Pavich EPD - Rezoning to Estero Planned Development
Zoning Staff Report
For Planning & Zoning Board Public Hearing

PROJECT NAME:	Pavich EPD
CASE TYPE:	Planned Development Rezoning
CASE NUMBER:	DCI2019-E002
PLANNING & ZONING BOARD DATE:	September 15, 2020

Figure 3 - Architectural Description

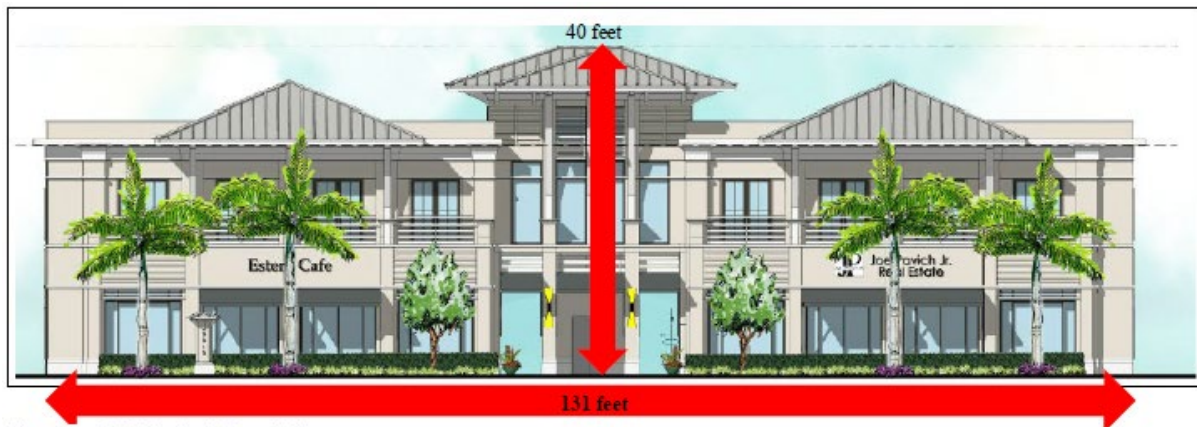
Staff review finds that the elevations in the Pattern Book do not generally comply with the architectural design standards in Section 33-517 of the Land Development Code which requires *‘the developer choose either a Mediterranean or Old Florida design for buildings in the Village, each such design standard allows for a broad palette of historical choices’*, and Section 33-334 which states that *‘the colors for commercial structures must be neutral, warm earth tones or subdued pastels’*.

Staff has found few of the above required architectural elements in the design, and the applicant has since changed the building color from Snowbound with Pure White trim to Agreeable Gray with Nebulous White trim. The predominantly gray structure does not conform to standards in Section 33-334 that requires neutral, warm earth tones or subdued pastels. The code does allow brighter colors to be utilized to create focal points or for brightly colored trims to create contrasts that complement the structure, however the structure is proposed to be gray with white trim and a gray roof. The horizontal massing and façade of the structure is modern in appearance, and the gray color with grillwork is not consistent with Old Florida or Mediterranean style required by the code.

Figure 10 Deviation Map

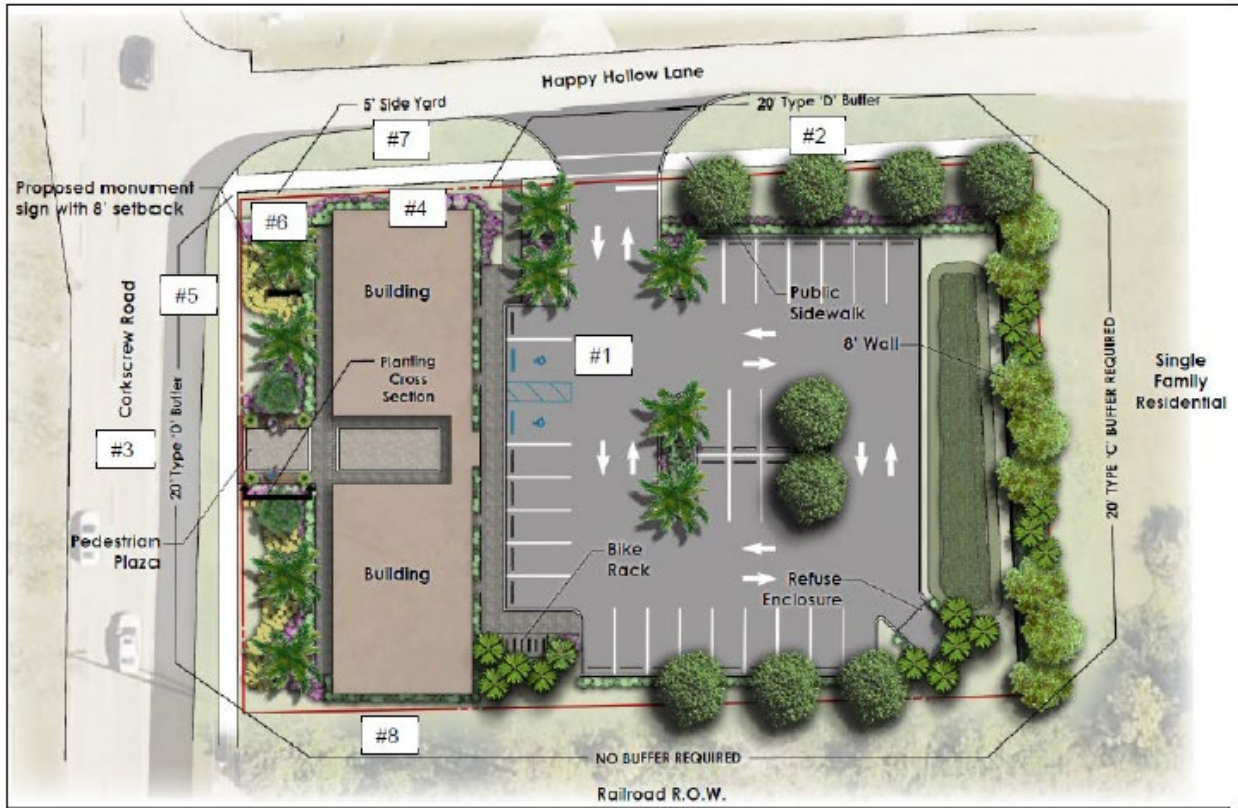
Staff is not opposed to the reduction in parking spaces as a bicycle rack is provided on-site, Corkscrew Road does have pedestrian and bicycle accommodations in the ROW, and that the project is proposed to be a multiple use development.

Staff Comment: Requested commercial zoning adjacent to rights-of-way require a 20 foot buffer with 5 trees required per 100 linear feet, and a 36” double hedge row. These buffers components are required along the length of Happy Hollow Lane; however, this deviation proposes to reduce the buffer to 15 feet in order to allow the parking lot spaces as shown in the highlighted area in Figure 10. The parking spaces are located 15.8 feet from the right-of-way, necessitating the deviation. The applicant explains that the buffer needs to be reduced due to the angle of the eastern property line which is not perpendicular to Corkscrew Road, affecting the buffer width. Staff is not opposed to this deviation as any potential impact with the parking area being 15 feet rather than 20 feet from the right-of-way will be minimal, and the applicant has stated that they will comply with the number of required plantings within the reduced buffer area.

Staff is concerned with what this deviation doesn’t include, which is a request to remove the buffer requirement at the northeast corner of the lot. The Master Concept Plan simply states “No Buffer Required”, but the LDC states in the Buffer Requirements that “The Type “D” Buffers required between commercial uses and rights-of-way may be waived, or reduced if the proposed building setback is within 25 feet of the right-of-way. This is not

Figure 11 - Master Concept Plan

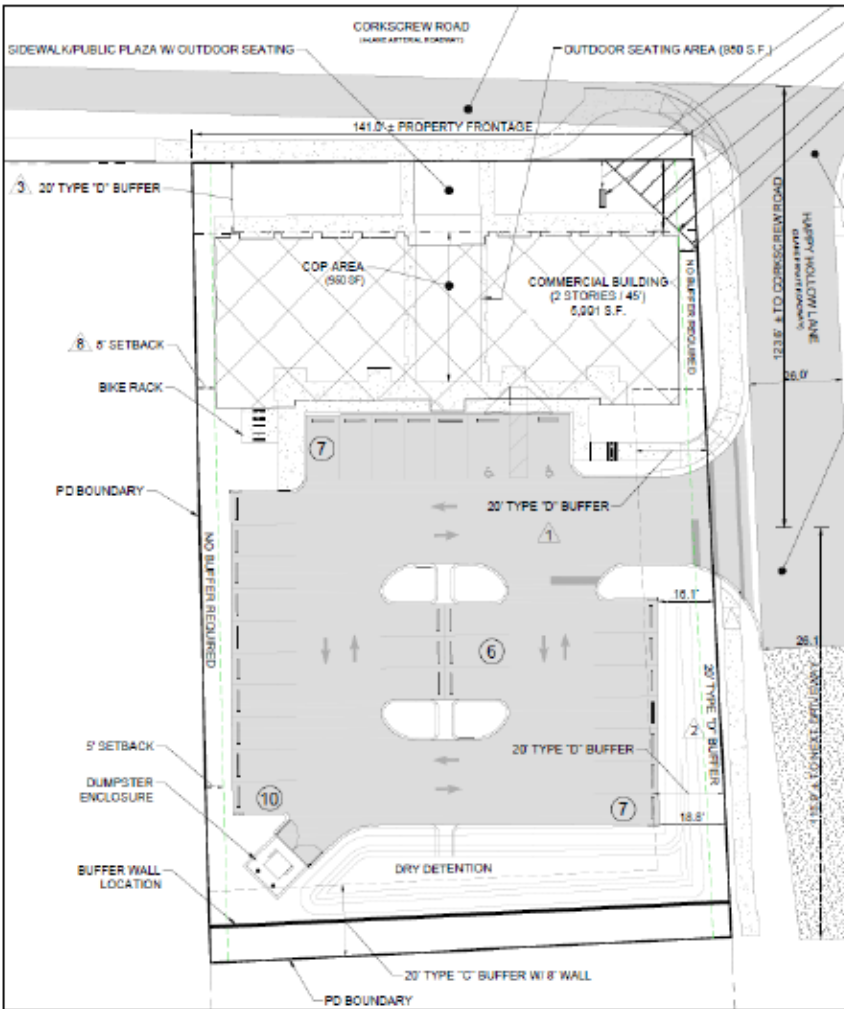
Staff is not opposed to this deviation as Happy Hollow Lane is a private street and the sight triangle will be

maintained. However, the scale of the project is somewhat overpowering for this intersection and landscaping should be used to soften the façade.

If this deviation is approved, it will necessitate approval of an additional deviation as a 20 foot Type “D” Buffer is required along the right-of-way of Happy Hollow Lane and the building would encroach into this buffer area. The Master Concept Plan notes that the buffer is not required in this area, but the applicant does not further explain this issue. This issue is further discussed in Deviation 2.
